ADDENDUM NO. 2 – Date: March 5, 2021

RE: RSD- Exterior Paint and Misc. Cosmetic Repairs at Janson ES and Savannah ES

1 JANSON ES | SITE PLAN - SCOPE OF WORK
SCALE: 1/32" = 1'-0"

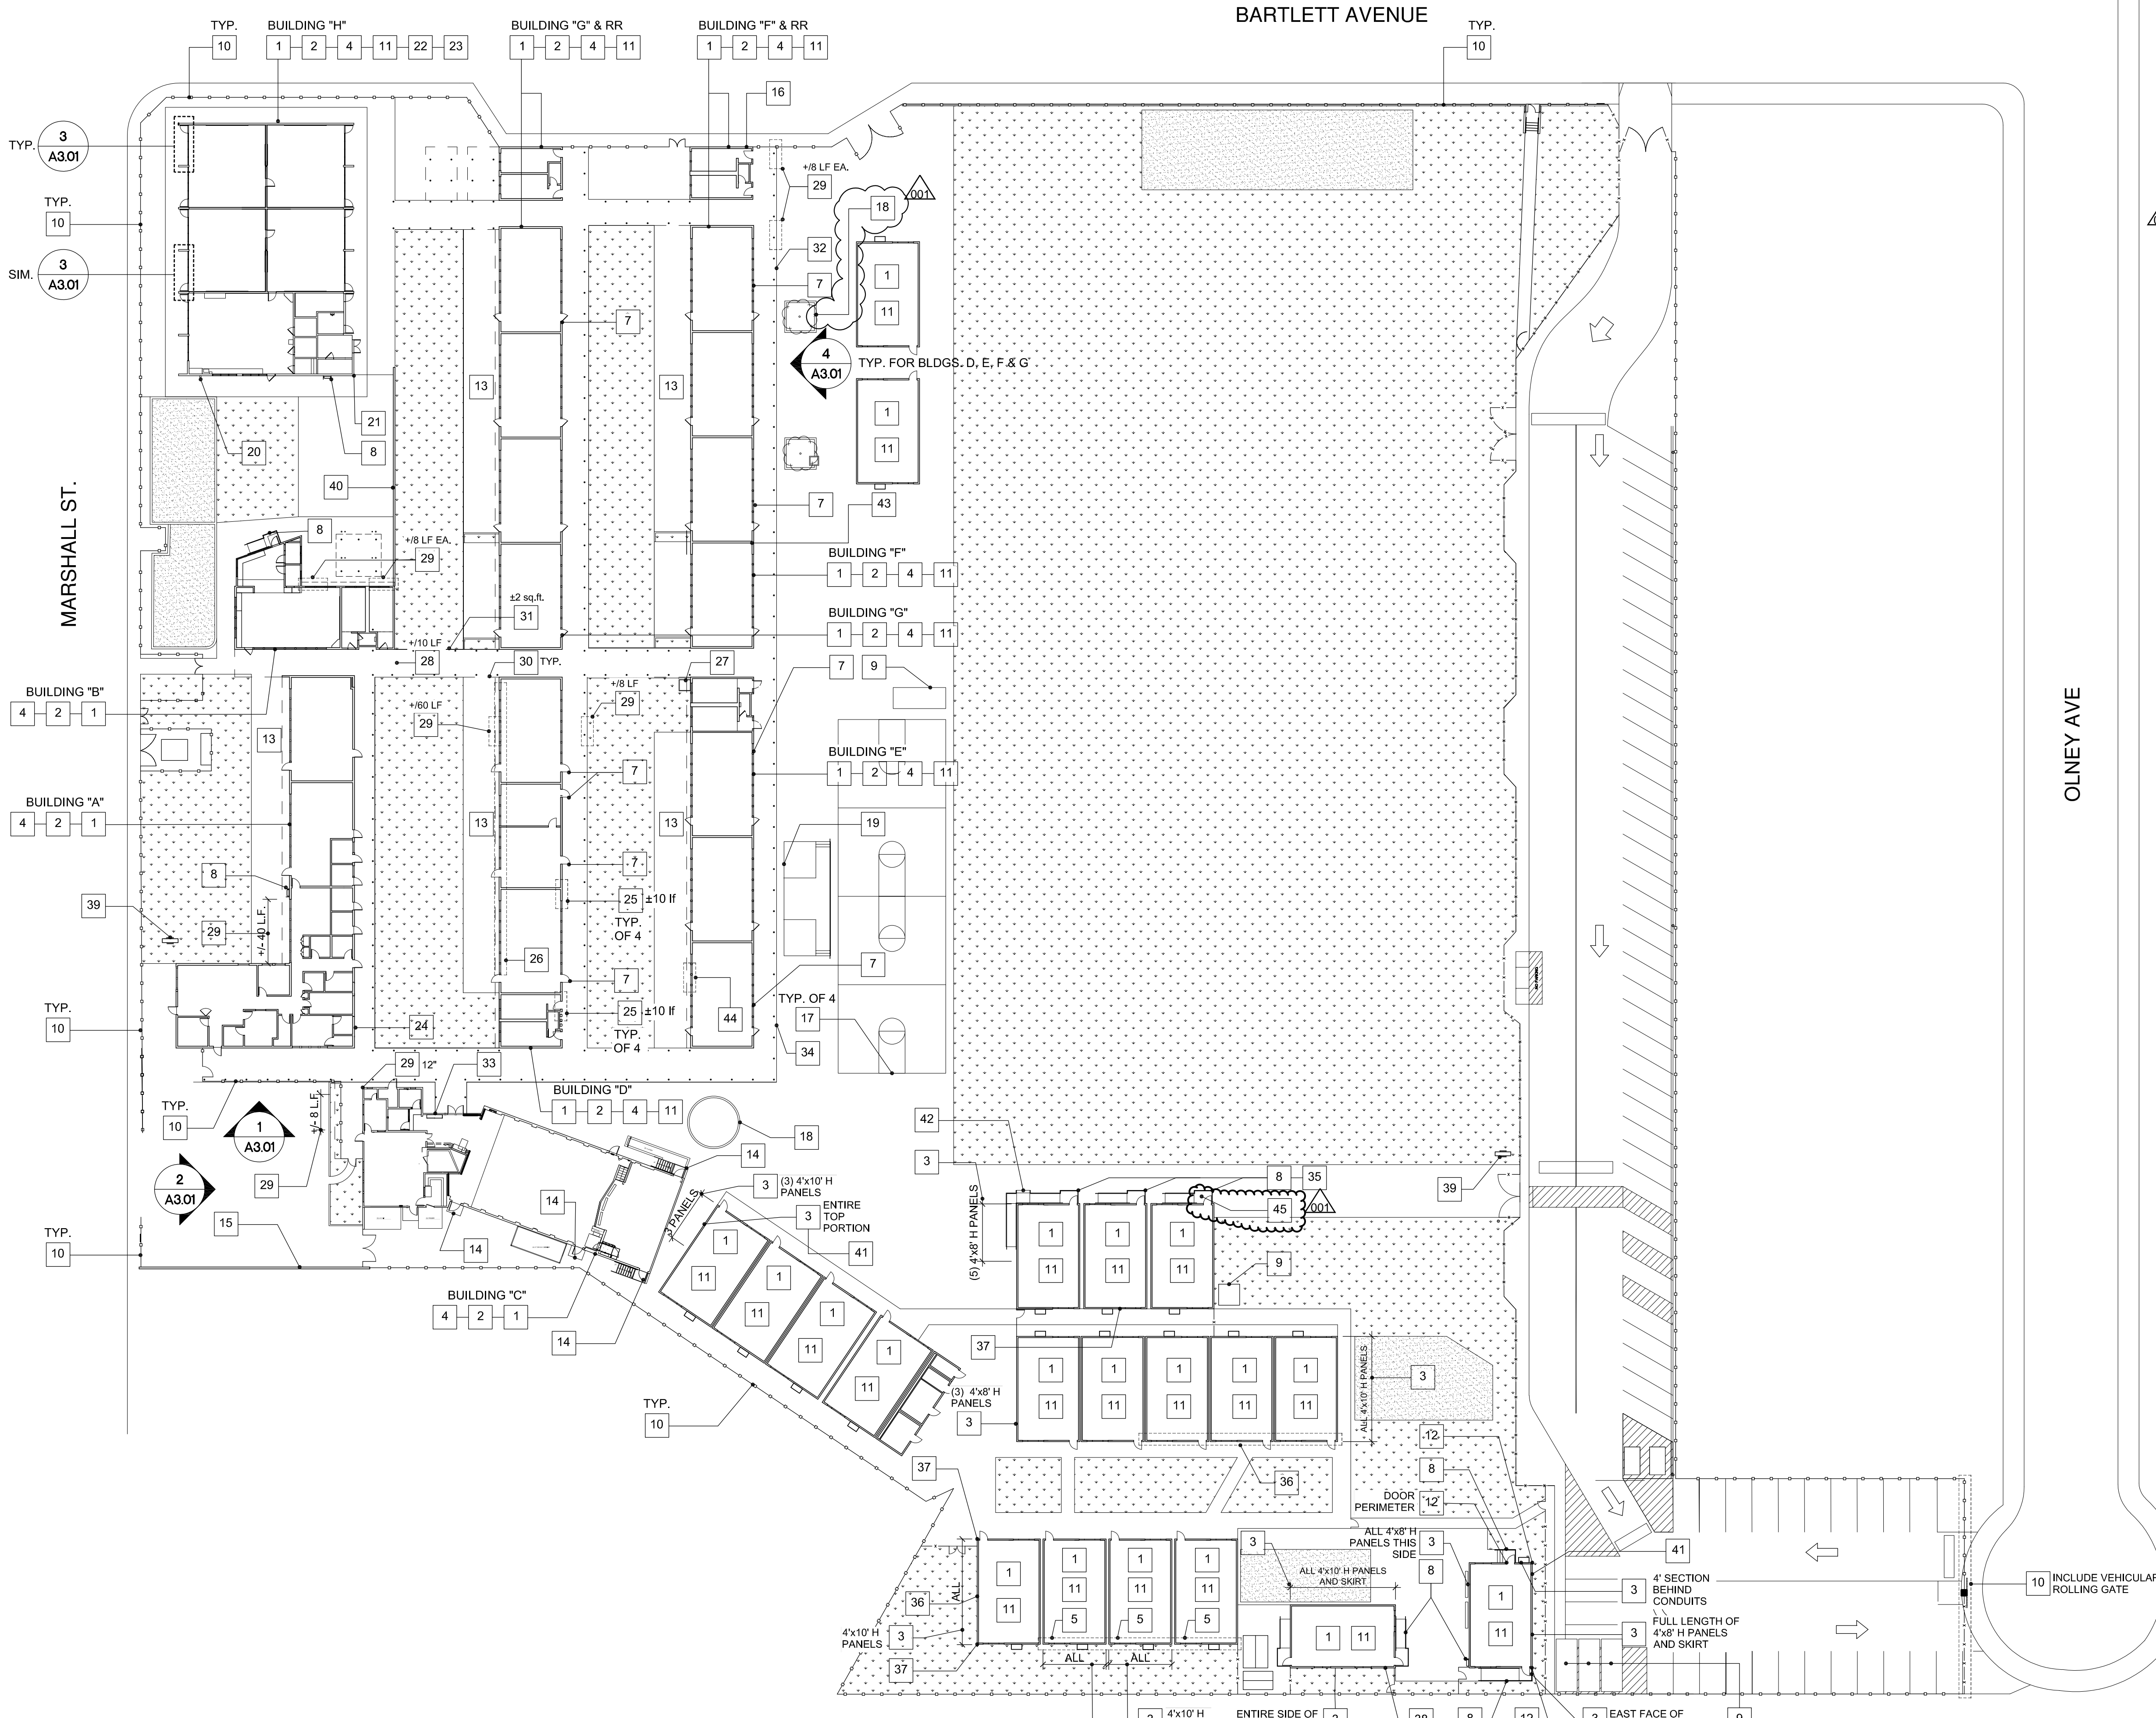
1. Janson ES Site, Sheet A1.01:

- a) **REVISED:** General Site Note “E”
- b) **ADD:** General Site Note “Q”
- c) **REVISED:** Key Note No. 9
- d) **ADD:** Reference to Key Note 18 on North Planter
- e) **ADD:** Key Note No. 45 and reference on the Site Plan

- 1. Question:** What is the scope for the "quotes" located on the eave's fascia boards?

- 4. Question:** Is the tree well on the North Side of Janson's play yard included in the Scope of Work?

- 5. Question:** At Janson ES: Is the repair of the underside of portable plywood overhang included in the Scope of Work?

- 6. Question:** Clarification of (E) storage "barns" (Applicable for both Sites)

- 7. Question:** Are the pipes and conduits on top of (E) canopies included in the Scope of Work? (Applicable for both Sites)

Response: Quotes on eave's fascia boards shall be painted over and re-painted to match (E). See revised Site Plan. Comply with General Site Note "Q" on sheet A1.01

Response: Yes, painting of planter is included. See revised Site Plan on sheet A1.01

Response: Yes, comply with Key Note No. 45 on revised Site Plan, sheet A1.01.

Response: Existing storage "barns" are not to be included in the Scope of Work. Comply with revised Key Note No. 9 on sheet A1.01 for Janson ES Site and with revised Key Note No. 16 on A1.01 for the Savannah ES Site

Response: No. Comply with revised General Site Note "E" on sheet A1.01 for Janson ES and Savannah ES set of drawings.

1 SAVANNAH ES | SITE PLAN - SCOPE OF WORK
SCALE: 1/32" = 1'-0"

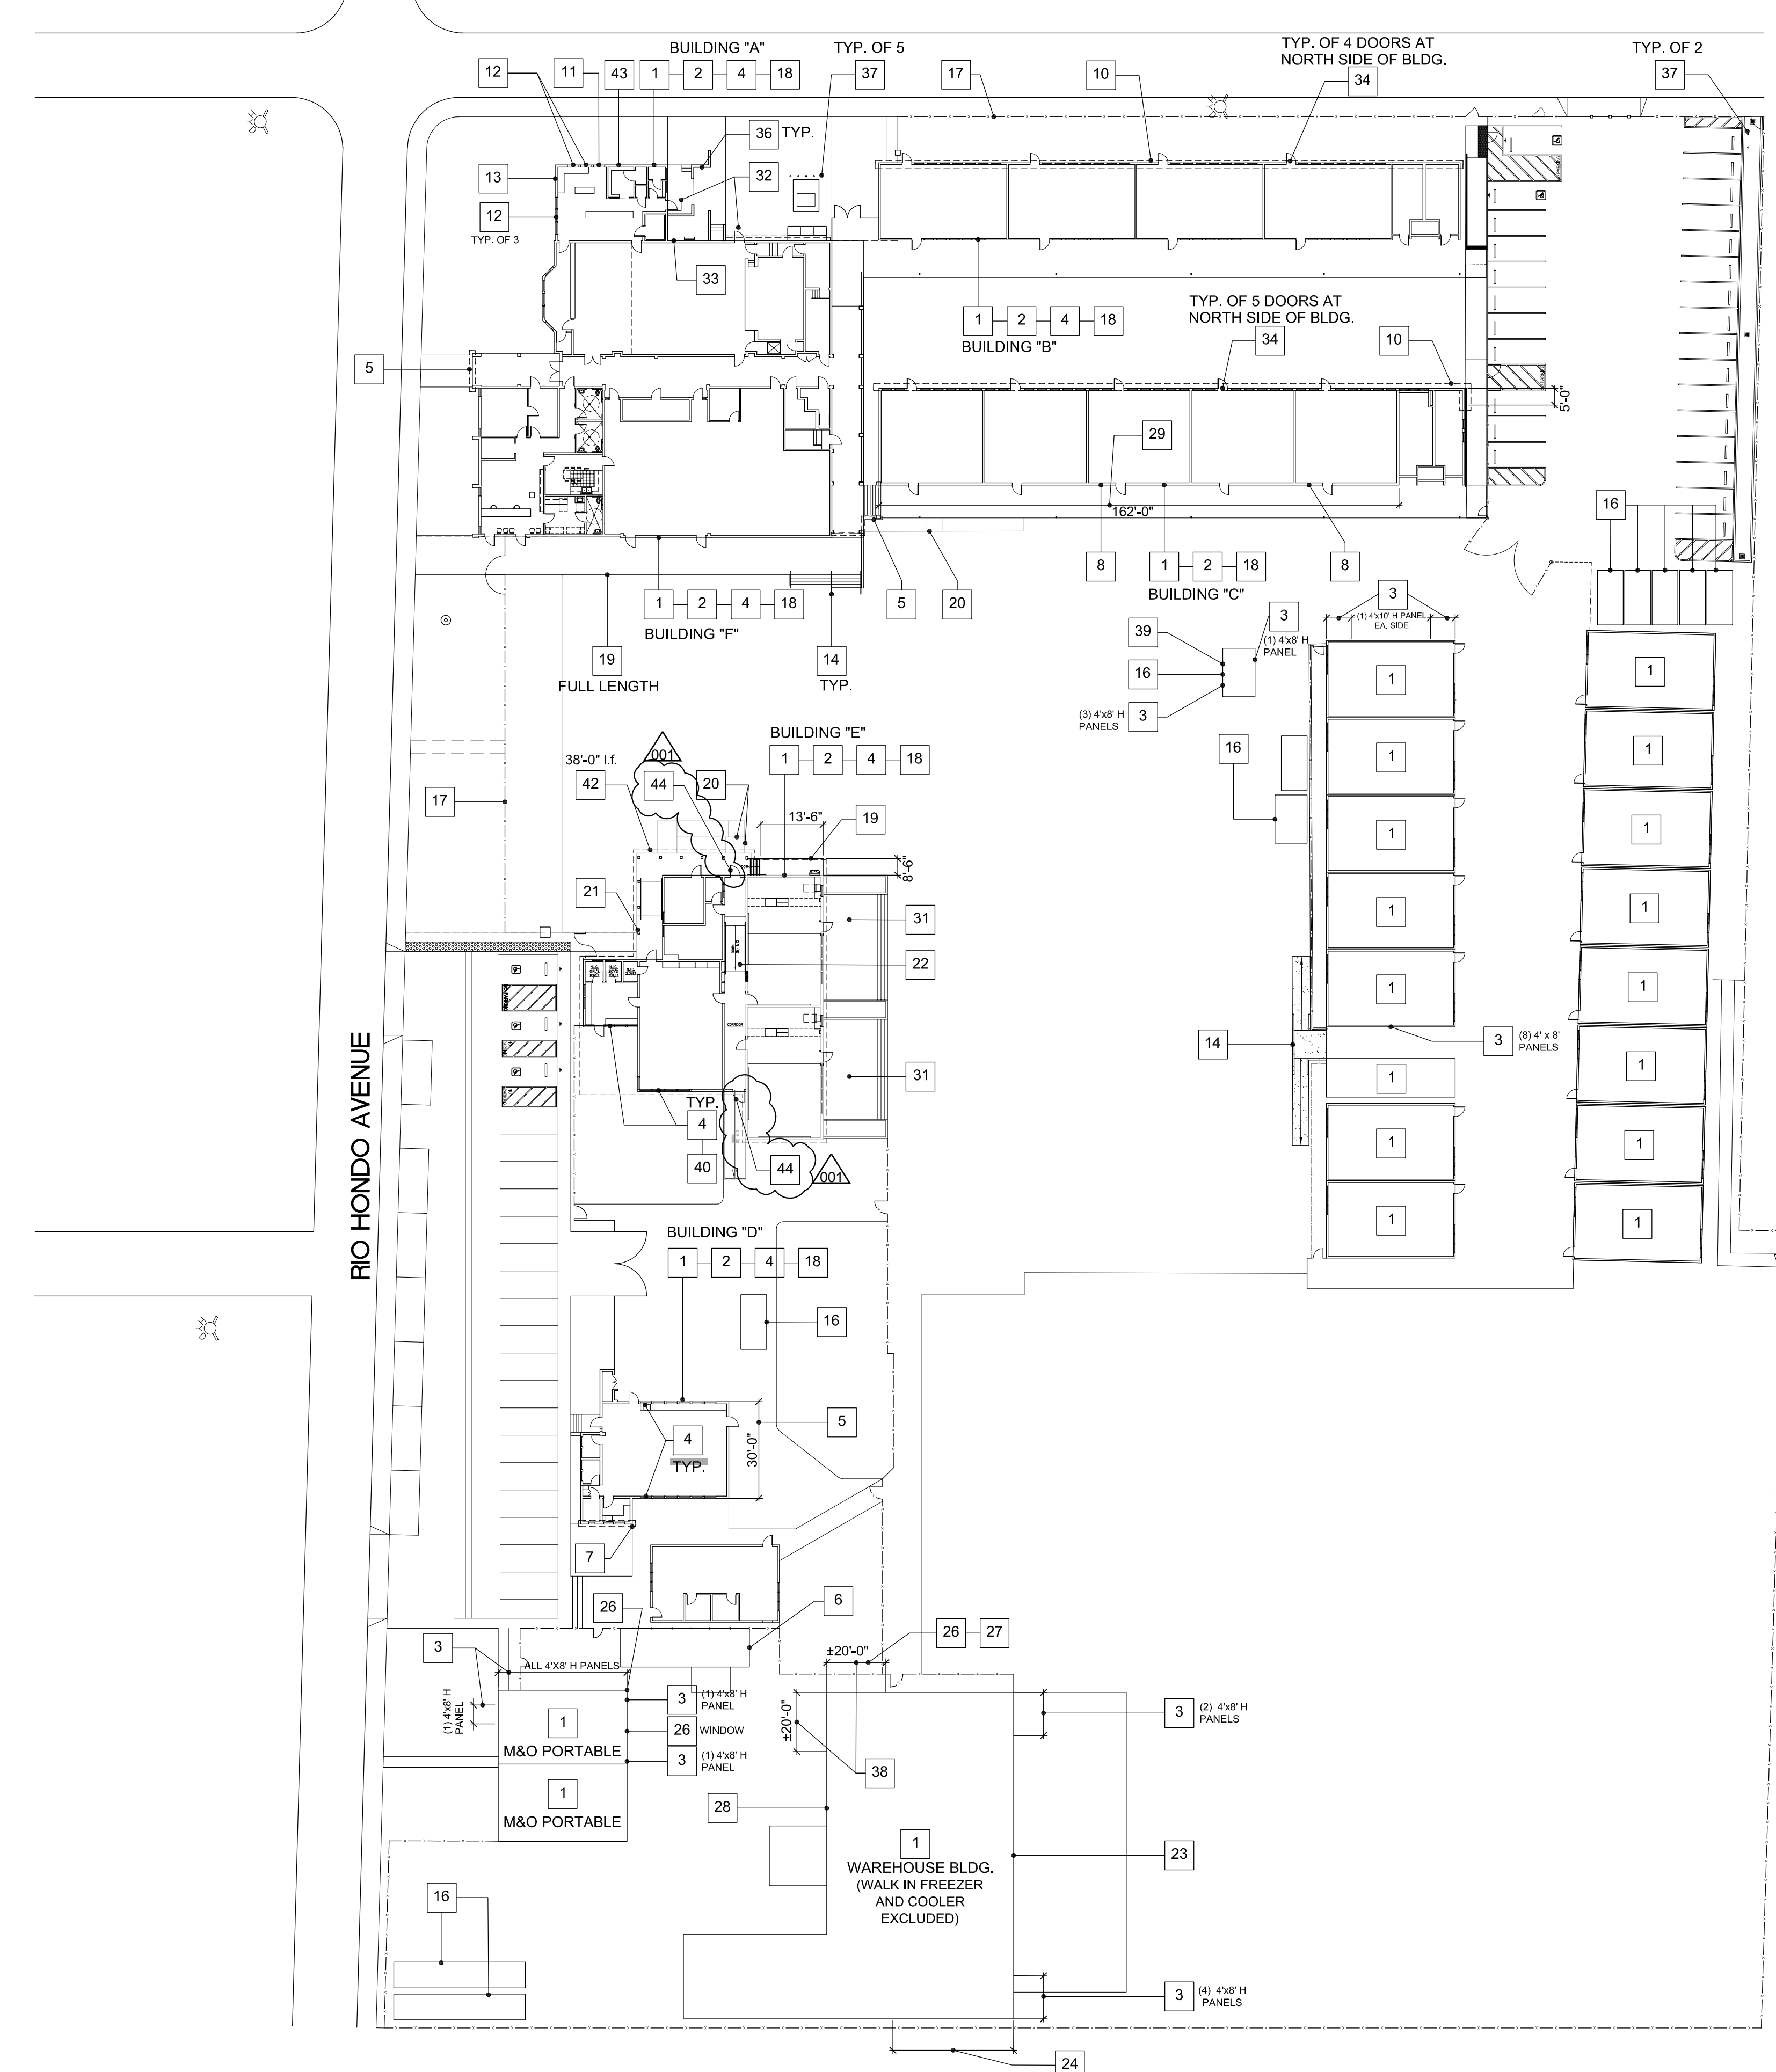
2. Savannah ES Site, Sheet A1.01:

- a) **REVISED:** General Site Note “E”

- b) **ADD:** General Site Note "S"
- c) **REVISED:** Key Note No. 16
- d) **ADD:** Key Note No. 44 and reference on the Site Plan

8. Question: At the Savannah Site: Will (E) CMU that is currently not painted be provided with new paint?

9. Question: At the Savannah Site: Do the doors at the North and South ends of the breezeway going to be painted in full (all sides)?

Response: No, Comply with General Site Note "S" on sheet A1.01 of the Savannah ES Site

Response: Yes, comply with Key Note No. 44 on sheet A1.01 of the Savannah ES Site
